License DPR-35
Docket 50-293

**PROPOSED CHANGES TO THE EMERGENCY
DIESEL GENERATOR (EDG) TECHNICAL SPECIFICATIONS
ALLOWED OUT-OF-SERVICE TIME (3.5.F, 4.5.F.1, and 3.9.B.1 and 2)**

ATTACHMENT A TO BECO LETTER 94-126
DESCRIPTION TO PROPOSED MODIFICATION TO THE TECHNICAL SPECIFICATION

Figure A-1
ALTERNATE AC (AAC) CONFIGURATION

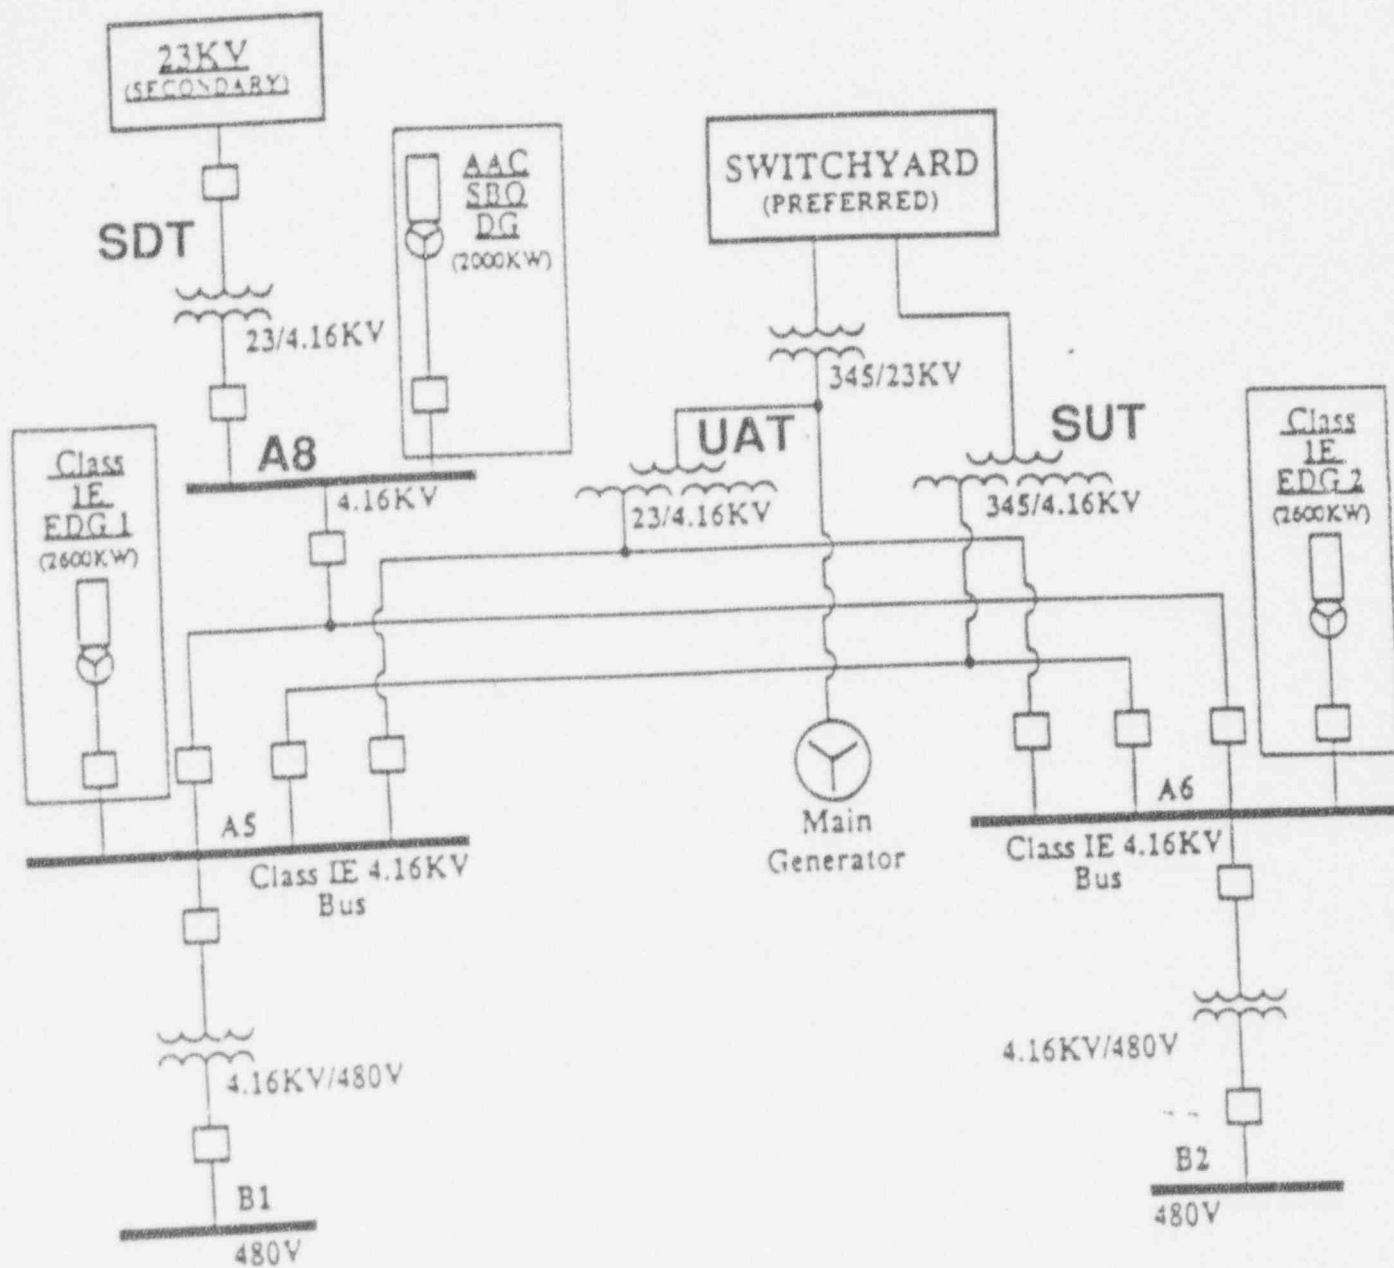
Pilgrim Nuclear Power Station Alternate AC power distribution is shown in Figure A-1.

Each EDG provides emergency onsite AC power to its associated emergency 4.16 KV bus A5 or A6 as shown on Figure A-1. Each of these buses by itself can provide the power required to mitigate a design basis accident. Normally, at 100% reactor power, busses A5 and A6 are supplied from the Unit Auxiliary Transformer (UAT). If the UAT is lost (due to a reactor scram), the emergency buses are automatically transferred to the Startup Transformer (SUT). In the case of a loss of offsite power (LOOP), the SUT will not be available, causing the EDG's to start automatically. Power to the emergency buses will be interrupted for approximately 10 seconds as the EDGs start, come up to rated speed, and then load onto the buses, automatically. In the event that an EDG fails to re-energize its associated bus, the Shutdown Transformer (SDT) will automatically load onto the failed

EDG's emergency bus approximately twelve seconds after the LOOP. The SDT is supplied from the 23 KV Commonwealth Electric line. In the event of a SDT failure, the Station Black-Out Diesel Generator (SBODG) can be manually loaded onto the failed EDG's emergency bus from the control room within 10 minutes. The SBODG is capable of supplying one Core Standby Cooling System (CSCS) pump and all associated 480 V loads.

Transient Condition: The most severe transient condition is the Station Blackout. In this case, normal off-site would be lost. UAT and SUT are no longer available. One EDG is being repaired, the other EDG fails to start. The SDT attempts to provide power to both emergency Busses A5 and A6. If SDT fails to provide the required power, the operator confirms that the plant is in an SBO transient, and manually starts the SBODG. The SBODG has demonstrated to be available to energize either bus within 10 minutes of an SBO event, and with the control room pull-to-lock switches, the SBO transient can be mitigated, with no equipment or core damage. Thus, during one EDG out-of-service, SBO transient can be mitigated with no adverse consequences.

Accident Condition: The most severe design basis accident condition is the LOCA with concurrent LOOP. When one EDG is out-of-service, if LOCA with LOOP accident occurs, the second EDG, SBODG and SDT are available to mitigate the accident condition. One EDG carries sufficient loads for ESF equipment to cover all design basis accidents. In addition the SDT can provide sufficient loads for ESF equipment.

Figure B-2

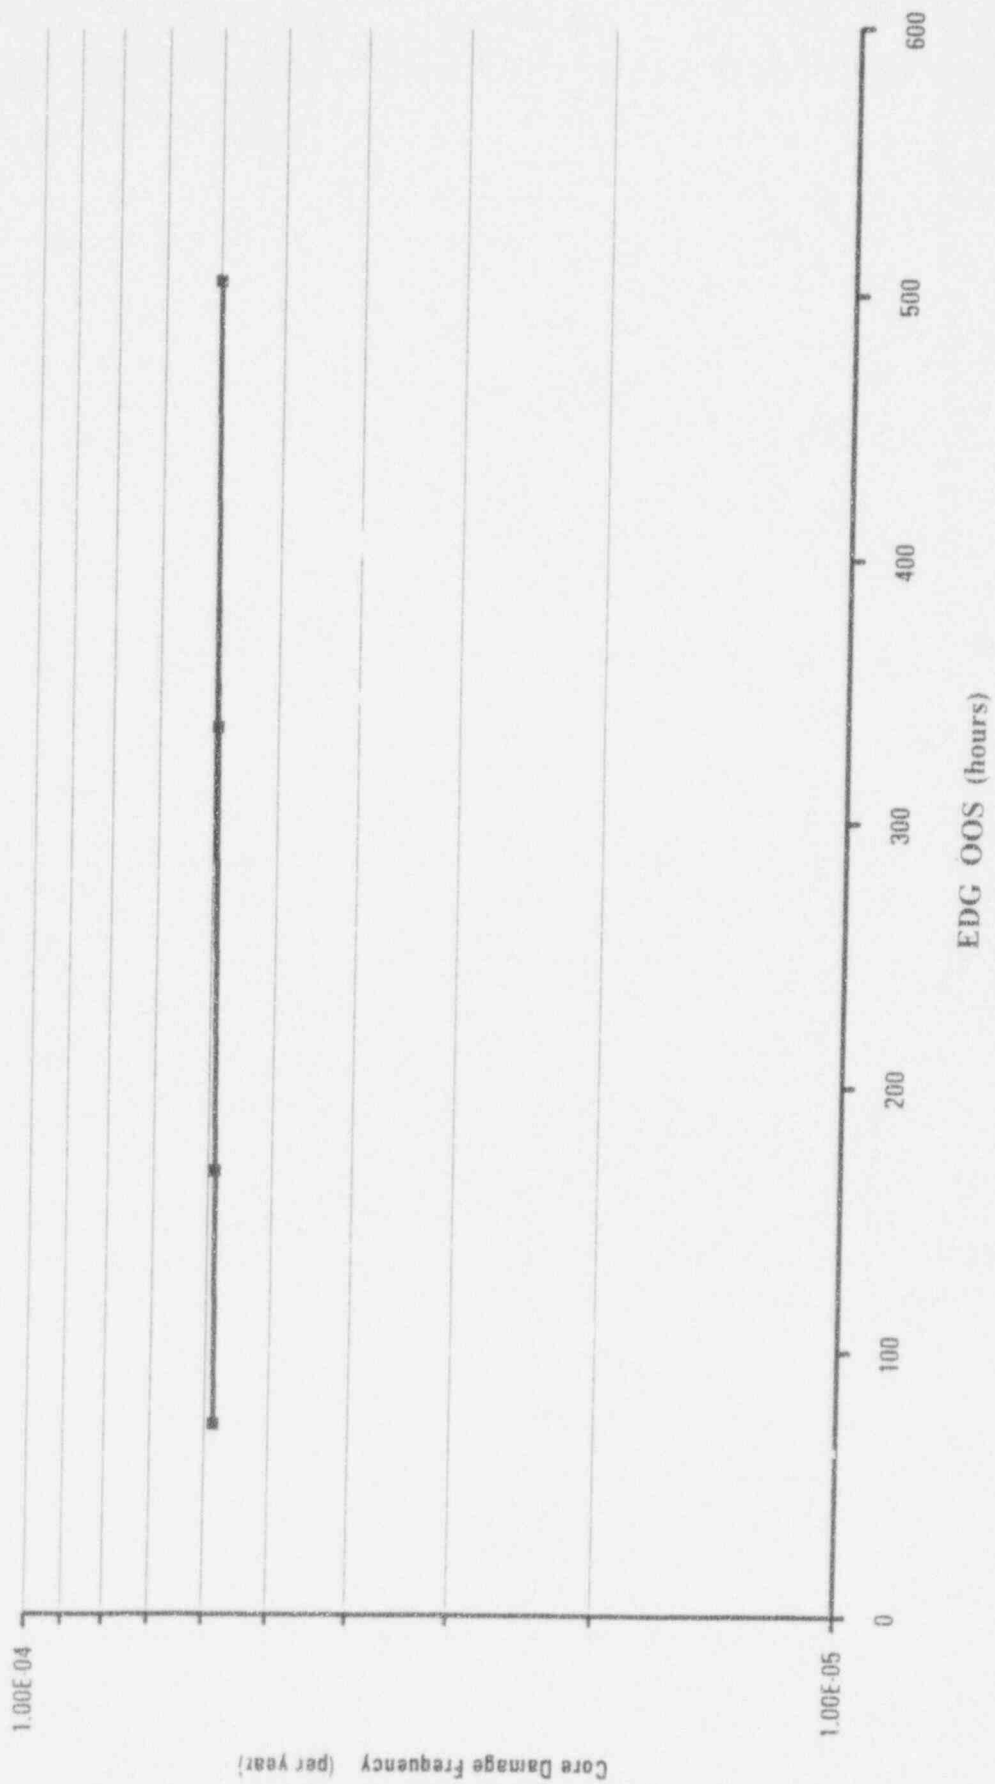
The results are shown in Table B-1. Extending the EDG OOS to 7 days for the worst case scenario results in a core damage frequency of $5.88\text{E-}5$. This change represents an increase in core damage frequency of less than one percent. These values are plotted in Figure B-2. A modest 0.56 percent increase in core damage frequency for the worst case maintenance duration certainly demonstrates the acceptability of going to an OOS of 168 hours.

The PRA uses mean values for its failure rates. The mean EDG frequency of corrective maintenance used by the PRA is $4.1\text{E-}4/\text{hr}$. The long term risk of core damage due to EDG unavailability can be determined using this mean value. However, because it is a mean value, with a somewhat symmetrical distribution, there is approximately a 50% chance that at any given time period the frequency could be higher than the mean value. Based on the PRA data base, over any given four month time period, the standard deviation of the corrective maintenance is approximately $3.3\text{E-}4/\text{hr}$. Therefore, over any four month period, there is about a 30% chance that the frequency could be greater than $7.4\text{E-}4/\text{hr}$, a 5% chance it could be greater than $1.07\text{E-}3/\text{hr}$, and a 0.03% chance it could be greater than $1.4\text{E-}3/\text{hr}$. Given the worst case maintenance duration of 168 hours, the aforementioned frequencies yield core damage frequency increase percentages of 1.24, 2.03, and 2.68, respectively.

Thus, assuming the maximum possible outage duration of 168 hours for every EDG maintenance, and assuming the highest frequency of maintenance (three standard deviations greater than the historical mean value), the resulting risk increase is still acceptable (2.68). However, it is expected that the actual risk increase using realistic data will in fact be marginal.
